Pymont Metro OSD – Residential Tower
Application Number SSD-49620481
Assessment Type State Significant Development
Development Type Rail transport facilities
Local Government Areas City of Sydney
Exhibition Start-End Date 12/03/2024 - 09/04/2024
Name Russell Hand
Phone 82751313

Sydney Metro West, Pymont Station

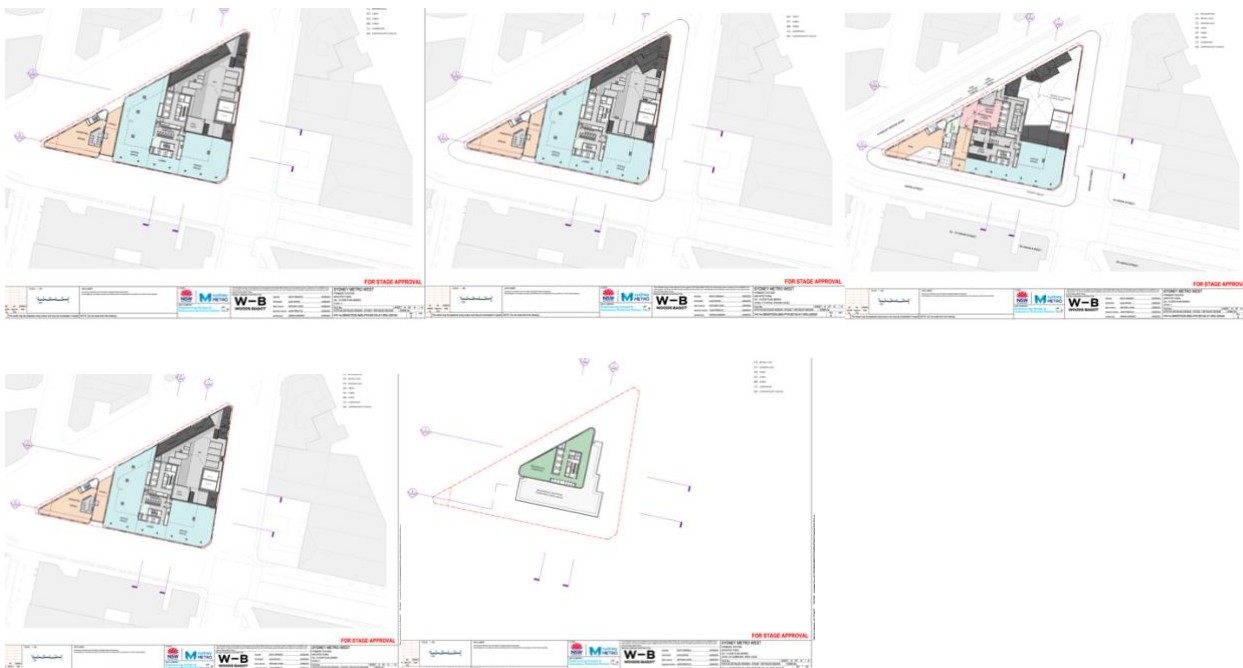
The inclusion of critiquing the proposed building's glazing choices which currently will cause mass bird and other flying urban wildlife strikes/deaths does require the DAP to inform/strongly guide the design teams to refine their principles so that this State Significant building and the ongoing design development of others DAP responsible buildings take responsibility for a better outcome for urban wildlife.

Not attractive or welcome to see when you walk, ride, drive or live and work in a glass tower building is the direct results of Bird strikes on our City Streets, or balconies, very upsetting for residents and visitors alike. No one wants to walk out of or into the Pymont Metro building seeing dead/dying birds on the pavements.

March 3 2024, SMH article 'Outcry over bird deaths at modern glass bridge'. Where the glass bridge owned by Marrickville Metro shopping centre that connects the two parts of the shopping centre came under fire for not protecting urban wildlife. The design followed the modern architectural trend for glass panels, particularly reflective glass, which leads to the death of millions of birds worldwide. The bridge glass is now being retrofitted with coloured glass and lasers and decals are installed to cover some panels with more modifications needing to be made as rainbow lorikeets continue to fly into the bridge. The bridge is invisible to the lorikeets. The Inner West Councillor Mathew Howard was to raise the issue at the council meeting on Tuesday as the number of birds 'striking' has been distressing for residents and shoppers. And hopes this sparks a bigger conversation about how our built environment can better support local wildlife and architecture be more friendly towards native birds.
